CITY OF ALBUQUERQUE

Re: 913 Silver SE Lot 19, 913 Silver Ave SW Albuquerue NM 87102 Traffic Circulation Layout Engineer's/Architect's Stamp 07-11-2019 (K14D118)

Based upon the information provided in your submittal received 07-15-2019, the above referenced plan cannot be approved for Building Permit until the following comments are addressed:

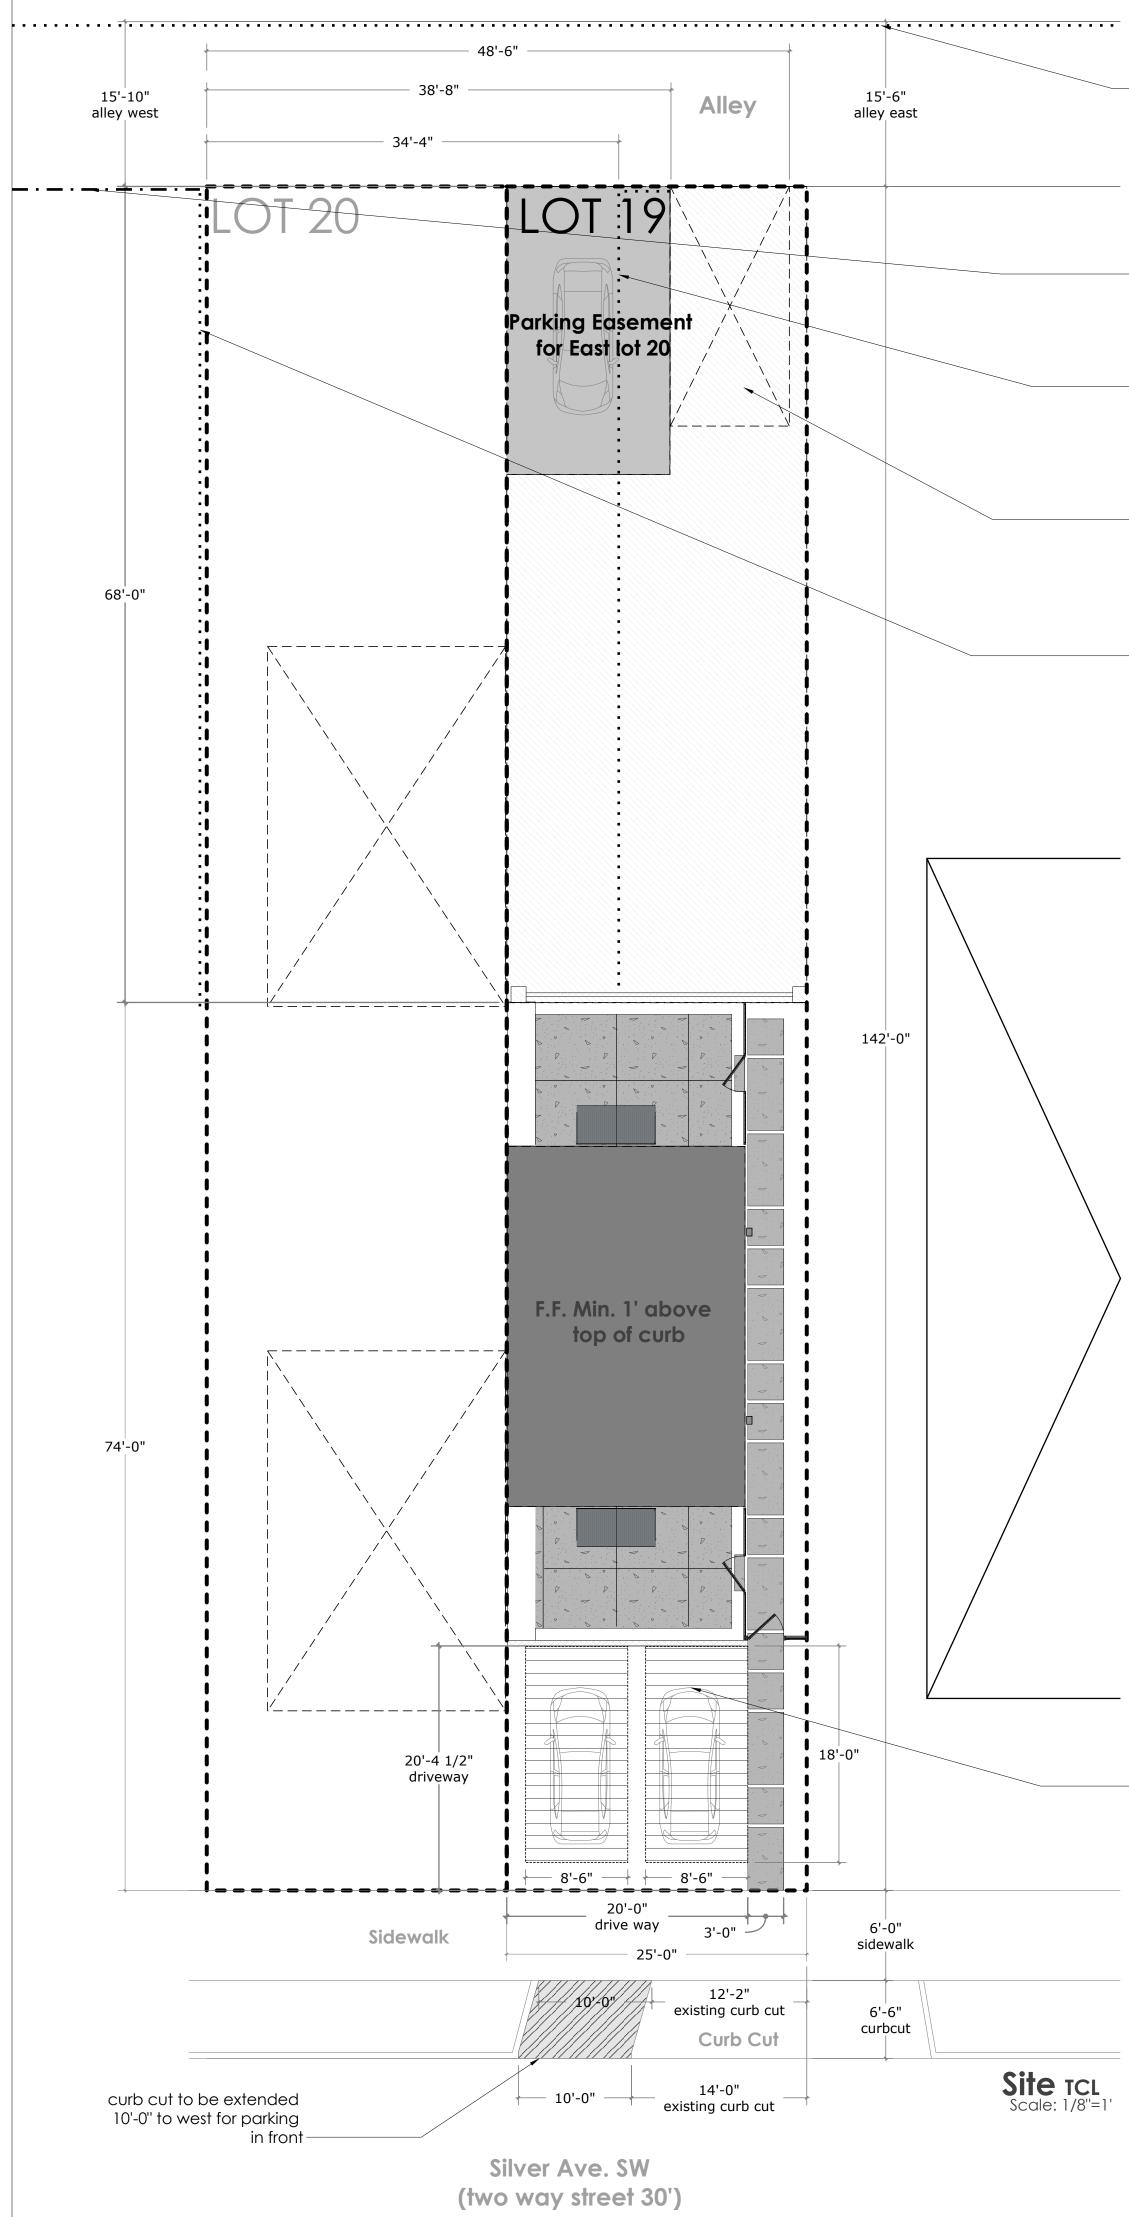
- 1. Please show a vicinity map showing the location of the development in relation to streets and well known landmarks.
- 2. List the number of parking spaces required by the zoning code as well as the proposed number of parking spaces including bicycle and motorcycle parking.
- 3. Per the Development Process Manual, Chapter 27 Drafting Standards, "Standard sheets must be 24" by 36" having a margin of 2' along the left and 1" on the top and bottom".
- 4. The scale must be shown on the plan. Per the Development Process Manual, Chapter 27, Section 2, Part B.1, on the following scales may be used:

- 1" = 20' 1" = 40' 1" = 50' 1" = 100' (for overall layouts only)
- 5. Show the clear sight triangle and add the following note to the plan: "Landscaping and signage will not interfere with clear sight requirements. Therefore, signs, walls, trees, and shrubbery between 3 and 8 feet tall (as measured from the gutter pan) will not be acceptable in the clear sight triangle.
 - Two measurement is shown for the existing curb cut. Please show the correct one.
- 7. The width of the drive allowed is 12 -22 ft.
